SITE DEVELOPMENT PLAN

Vertical sidebar containing: REVISIONS table, TAIT & ASSOCIATES logo and address, SITE DEVELOPMENT PLAN title, PROJECT NAME: HONOR CHARTER SCHOOL HIGHMARK SCHOOL DEVELOPMENT 8250 BENT GRASS MEADOWS DR., DRAWING NO., DATE, CHECKED, DATE, REVISION, DATE, JOB NO., and SHEET INDEX S-1 OF 48.

V1_Site Development Plan.pdf Markup Summary

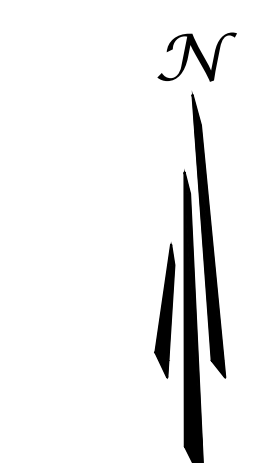
delete this as this when approved will be for construction

please update to 25-337

please update to
25-337

Please provide the parking plan and table on a sheet based on the Land Dev Code . Identify dimensions, ADA spaces, Loading/drop off areas, Bus Parking ; staff Parking (you will need both categories since you are 2 schools in one)

Show all property lines and depict 25 foot building setbacks per the checklist and provide landscape , buffer setbacks per Chapter 6

is there a chained Emergency access?

Please add site development plan checklist add missing items

depict the playground as it is to be approved with this site dev plan

what is this area? what is surface

is an opaque buffer screen wall provided adjacent to residential homes? a 15' buffer is required.

delete this as this when approved will be for
constriction
